# Xerox®VersaLink® Product Enhancement Document

Description of new features and enhancements to the products specified below.

Release Date: **June 28, 2019**

### 1. Additional Audit Log Events

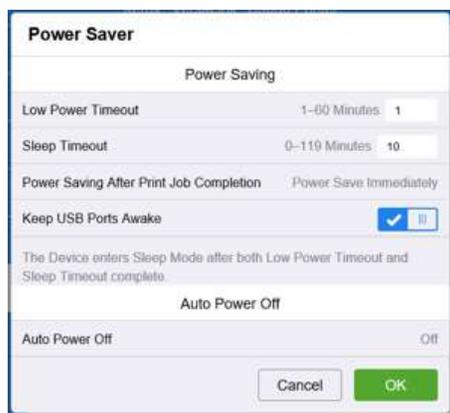
More events for security and other settings are available in the device's Audit Log.

## 3. Caveat: USB may not be recognized on Win7.x/8.x after upgrade

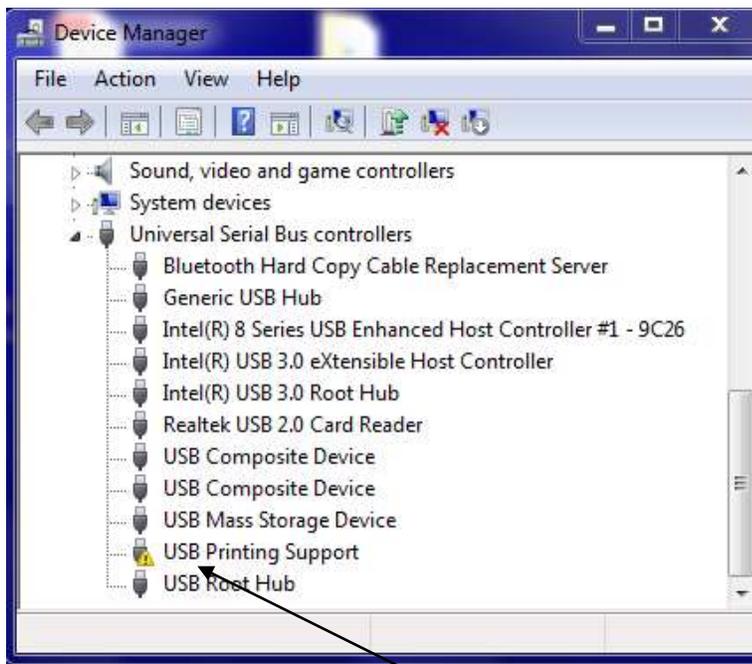
A device connected to a PC running Windows 7 or 8 with a USB cable may experience an issue of the device not being recognized by the PC. This issue is not expected to occur on PCs running Windows 10.

After upgrading to the release, the PC may need to update the USB driver and reassign it to the USB Composite Device driver.

**Note:** Customers who have a **Yellow Warning!** next to the USB Printing Support will need to Right Click on the USB Printing Support line and select Update Driver Software.

### ThinPrint WebUI

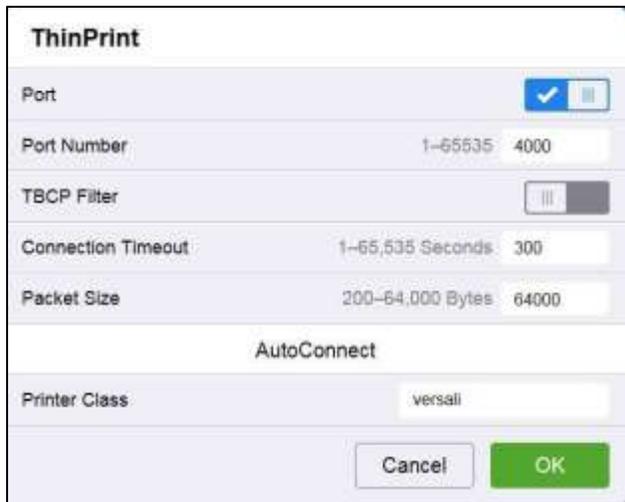
Once the ThinPrint Protocol is enabled, the Admin has access to the settings below. The port must be enabled. The default port number for ThinPrint communication is 4000.

**Note:** Although a different port number can be configured. It is important not enter a port number that is already in use.

### ThinPrint Server Settings

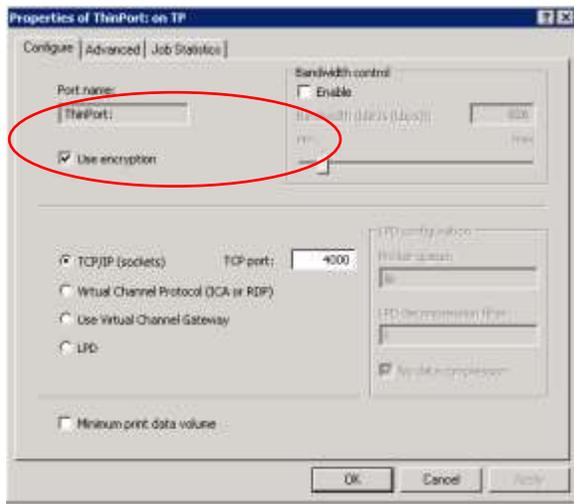
**Note:** The ThinPrint Engine/Server output queue and the Xerox device ThinPrint settings must both be set to TLS encryption for print jobs to be encrypted (see more below).

## ThinPrint Device Settings

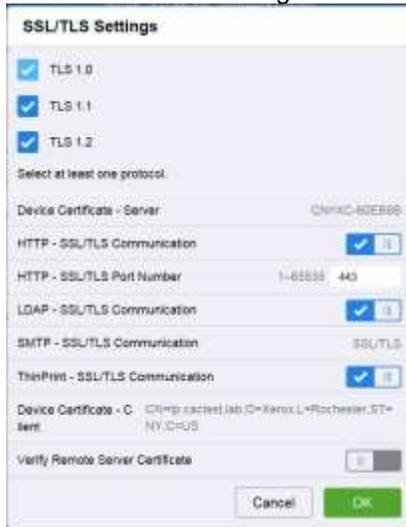
- Unencrypted print jobs from the server will not be accepted by ThinPrint protocol when TLS encryption is enabled on the print device.
- Cloning of the ThinPrint settings is not supported.
- Use of MIBS / OID string commands for ThinPrint settings is not supported.
- Audit Logging of the ThinPrint enablement / configuration is not supported.
- Thin Print may require the use of TLS 1.0 for encrypted job communication.
- Not applicable to Xerox® Phaser® 6510, Xerox® WorkCentre® 6515

Figure 1: Output Destination shown when optional **Office Finisher LX** is installed.

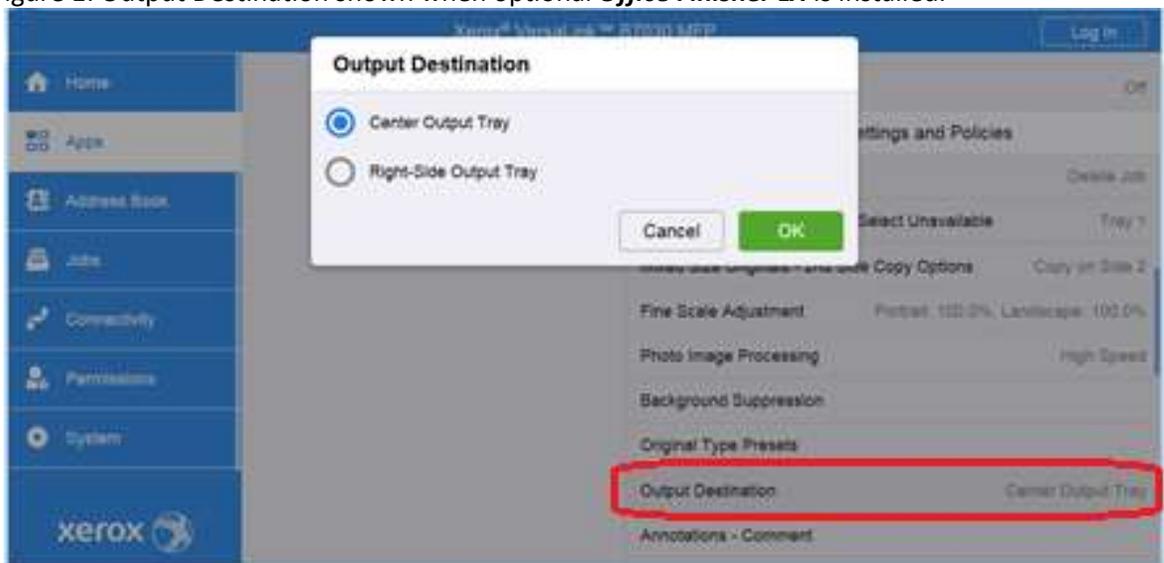
This feature addresses an issue for devices with the optional Office Finisher LX installed. Copy jobs without finishing options selected were limited to output the job to the Center Output Tray where offsetting cannot be performed. A new Admin accessible setting is available on the Embedded Web Server (EWS) to default copy job output to the finisher tray. This provides the ability to offset the sets with or without finishing options selected.

Selections are "Center Output Tray" (default) or "Right-Side Output Tray" (finisher).
